Access Compliance Report

Public Rights-of-Way

(Curb Ramps)

Intersection ID: 4102	Main Street: LAMPKIN_WY	Cross Street: PARK_WALK_WEST	Location: SW
ADA ID: 8BF7E90EECDF	Ramp Type: PerpDiag	Initial Pass/Fail: Fail	Overall Compliance: No
		Severity Score: 25

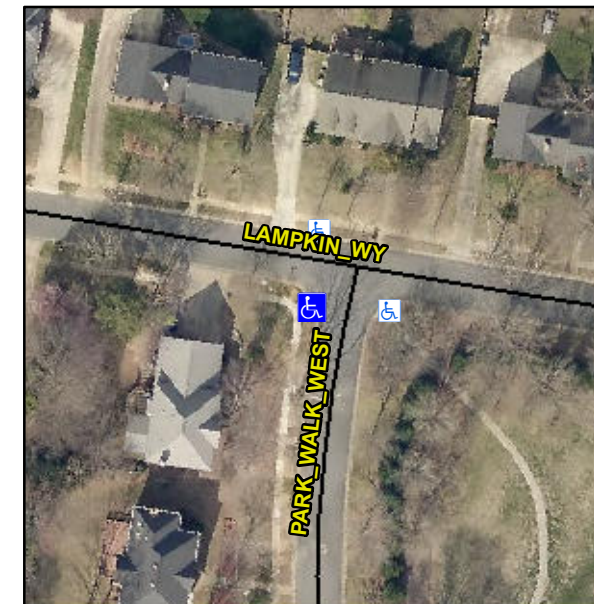
Not Found, R304.5.3

Compliance	Description	Data	Compliance	Description	Data
N/A	Ramp Length (in)	90.0	Yes	Ramp Slope (%)	5.1
Yes	Ramp Width (in)	48.0	No	Ramp XSlope (%)	8.0
N/A	Flare Type LT	N/A	N/A	Flare Type RT	N/A
N/A	Flare Slope LT (%)	N/A	N/A	Flare Slope RT (%)	N/A
N/A	Flare Traversable LT?	N/A	N/A	Flare Traversable RT?	N/A
N/A	Landing Length (in)	N/A	N/A	DWS Provided?	N/A
N/A	Landing Width (in)	N/A	N/A	DWS Contrast?	N/A
N/A	Landing Slope (%)	N/A	N/A	DWS Length (in)	N/A
N/A	Landing X Slope (%)	N/A	N/A	DWS Full Width?	N/A
N/A	Landing Curb? (Y/N)	N/A	N/A	DWS Offset (in)	N/A
N/A	Shared Landing?	N/A			
N/A	Gutter Ponding?	N/A	N/A	Gutter Slope (%)	N/A
N/A	Gutter Lip Ht (in)	N/A	N/A	Gutter X Slope (%)	N/A
N/A	Painted X Walk1?	No	N/A	Painted X Walk2?	No
	X Walk 1 Direction	To E		X Walk 2 Direction	To N
N/A	X Walk 1 Width (in)	N/A	N/A	X Walk 2 Width (in)	N/A
	X Walk 1 Slope (%)	4.2		X Walk 2 Slope (%)	6.5
	X Walk 1 X Slope (%)	9.0		X Walk 2 X Slope (%)	7.2

Remove & Replace Curb Ramp With Two New Directional Ramps or Equivalent.
